May 19, 2020

**RE: 62 Ellenwood Avenue**

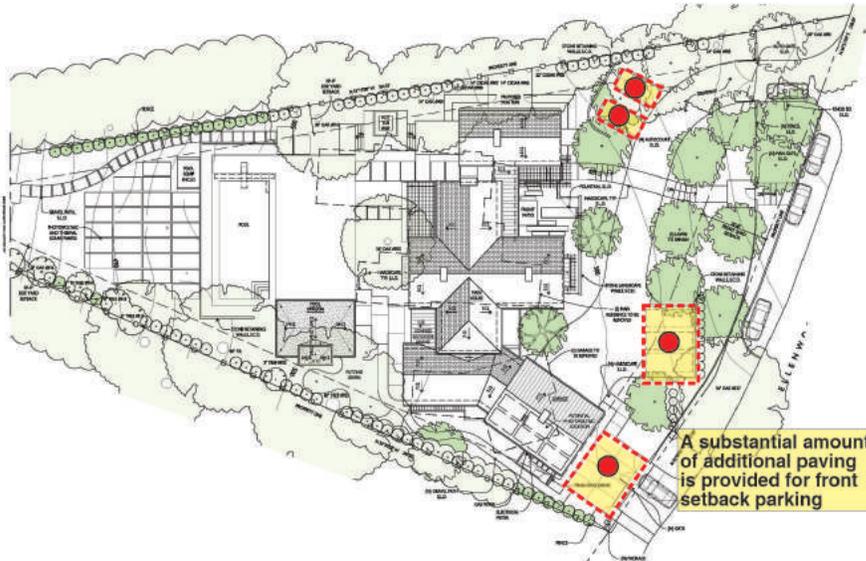
1. The additional landscaping in the front setback will be a welcome feature to integrate the home into the surrounding neighborhood, but the substantial additional paving proposed to provide at least six additional parking spaces seems out of character with the immediate neighborhood.

**Recommendation:** Remove some of the additional paving.

**Change in roof form and wall material seems arbitrary**

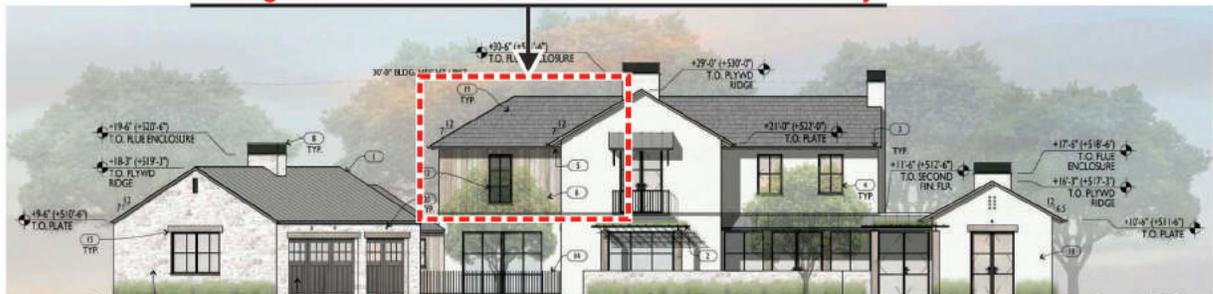
2. The change in roof form and wall materials on the second floor south wing of the house seems arbitrary, and an unwelcome change from the traditional forms and simplicity of the house style.

**Recommendation:** Match the roof form and wall material of the other second floor masses.

**Match roof form and wall material of other roofs**
